RESPONSE TO REQUEST FOR INFORMATION - SECTION 4.55(1A) MODIFICATION TO CONSENT – EXPANSION TO THE PINES CARAVAN PARK – 8 HEARNESE LAKE ROAD, WOOLGOOLGA – MP08-0005-MOD 2

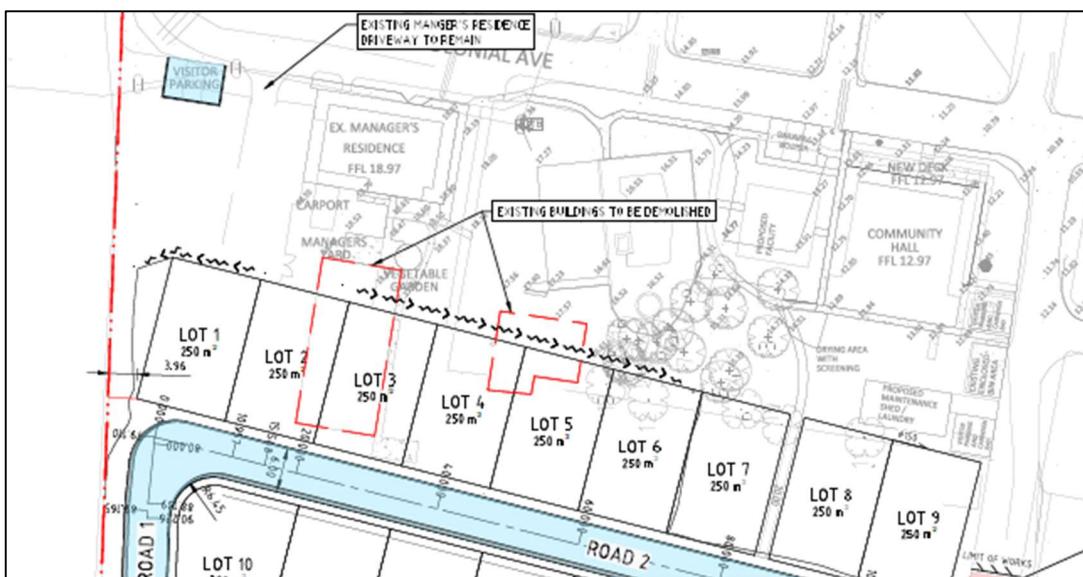
2. The Department requested confirmation of the demolition of structures within the area of sites 1 to 9. In the submitted Response to Request for Information it is unclear whether the structures have development consent for their demolition.

The Department seeks confirmation that the structures have approval for demolition. If approval has not been sought or granted, the demolition can be incorporated into the proposed modification if required.

Response: Demolition approval has not yet been granted for the structures. Given the demolition works are necessarily associated with the approved development; HTA requests the works be incorporated into the proposed modification. The following images show the original approved plan (Consent dated 4 June 2012; MP08_0005) and the current Master Plan (top and bottom image respectively). By way of comparison, the buildings require demolition in both the original Consent and the current proposal; therefore, the inclusion of the demolition works is not substantially different to the original Consent.
